Re: Response to Planning Panel Records of Briefing – 80 Betty Cuthbert Drive, Lidcombe
(DA2021/0435)

PPSSCC-283 – Cumberland – DA2021/0435, 80 Betty Cuthbert Drive, Lidcombe, Lot 74 in DP 1141724 being 80 Betty Cuthbert Drive Lidcombe, Construction of a part one (1), part two (2) and part three (3) storey multiple sclerosis (MS) wellbeing centre inclusive of 20 x 2 bedroom units for temporary accommodation, provision of car parking, new access driveways, drainage and stormwater detention works and tree removal.

Fig 1a

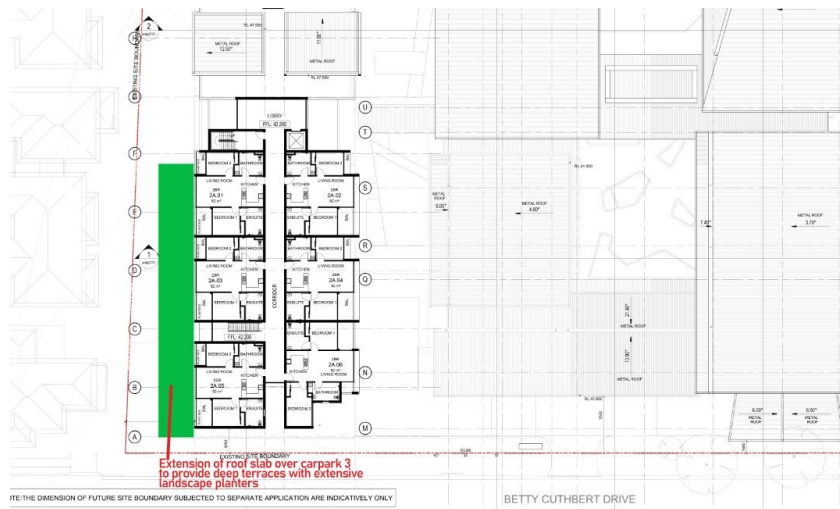
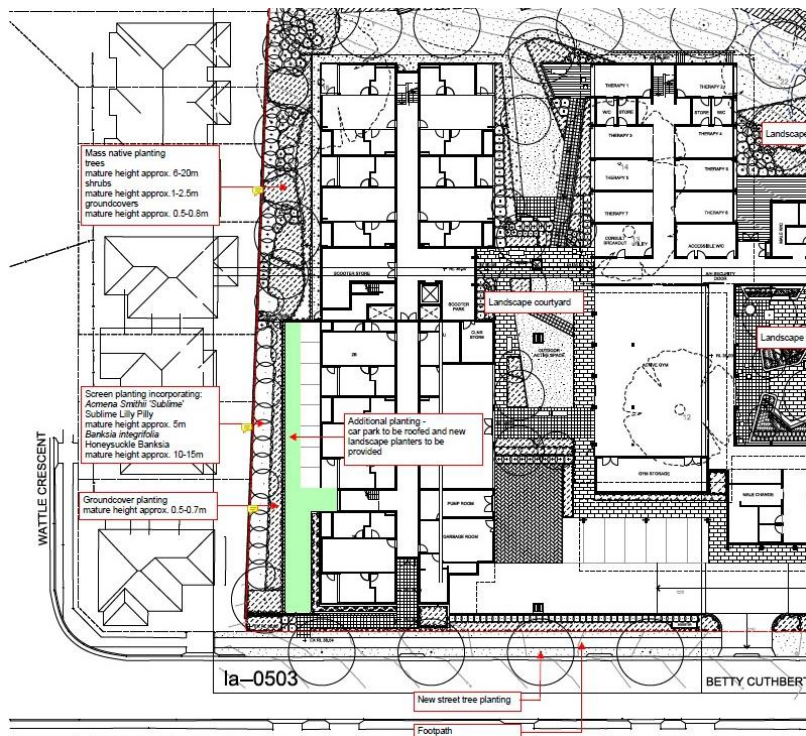
- *Lowering carpark 3 such that it can be roofed and landscaped and integrated as open space for rooms.*
- *Provide a landscape outlook for the waiting room, café/lounge, kitchen by providing a landscape setback between carpark 1 and the building.*
- *Locating carpark 1 on ground.*
- *Providing a landscape setting, public footpath, and row of street trees along Betty Cuthbert Drive*

In response to the panels comment concerning Carpark 3, this area could be roofed creating the opportunity to provide deep terraces off the apartments with extensive landscape planters that will enhance the landscape screen planting along the southern boundary of the site adjacent to the existing residential. This design amendment would also improve the acoustic quality of the development. MS Lidcombe would consider this amendment and request that this change to the design be addressed as a Condition of Consent. (Refer to Fig 1a & 1b_

Fig 4a

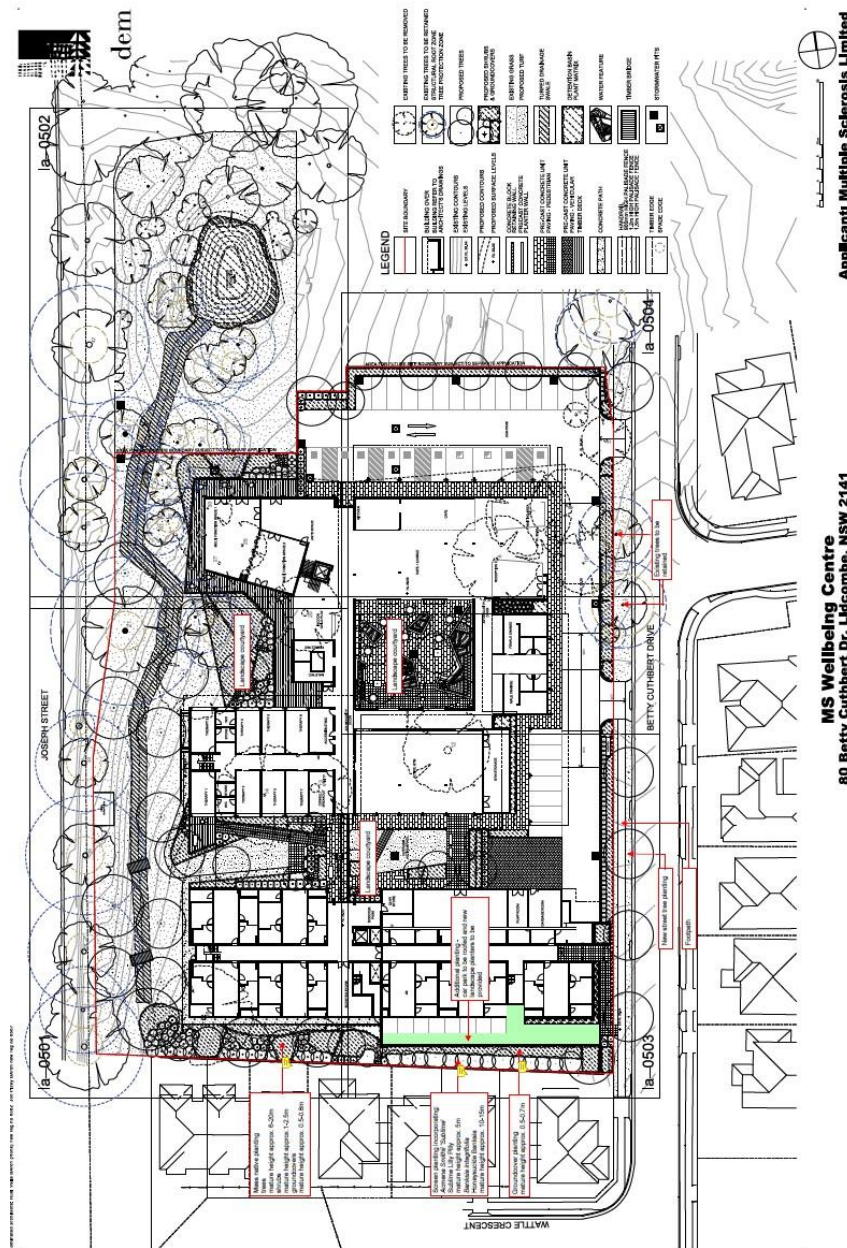
- The Panel noted that community concerns were raised regarding streetscape quality and height of buildings, and that 21 trees are to be removed. There is a potential for trees to be replaced along the street edge and to the rear of the development. This would assist in providing residents with visual relief from the busy road and an outlook to the eastern open space, while improving the view from the street into the property, and the streetscape.

Although 21 trees are to be removed, tree replacement mitigation is compliant with Council requirements as outlined in Council’s Urban Tree Strategy 2020 and DCP.

Refer to the Landscape Plan Fig 4a
